Access Compliance Report Public Rights-of-Way (Pedestrian Signals)

Main Street: **IRVINE_AVE** Cross Street: **MESA_DR** Location: **N**

ADA ID: **SGAT220128132204** Signal Type: **One Push Button-Non APS** Overall Compliance: **No** Severity Scores: **BTN 1: 35** **BTN 2: N/A** **No BTN: N/A**

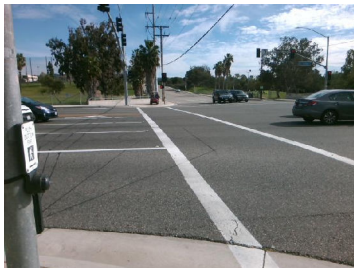
Possible Solutions: Replace Signal Push Button With APS Button. Remove and Replace Clear Space.

Surveyor Notes: Button 2 for Bike Lane

OC Std/PROW: R404.2, R403.4, MUTCD 4e.08
